Shearwater Teric Firmware Release Notes

VERSION 18 2020.06.01

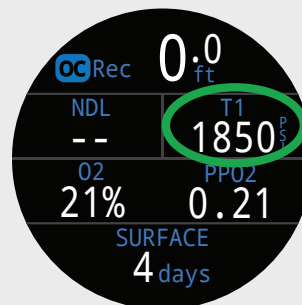
IMPROVE In the OC Rec Standard layout the TTS (top-right) location can be replaced by alternate displays.
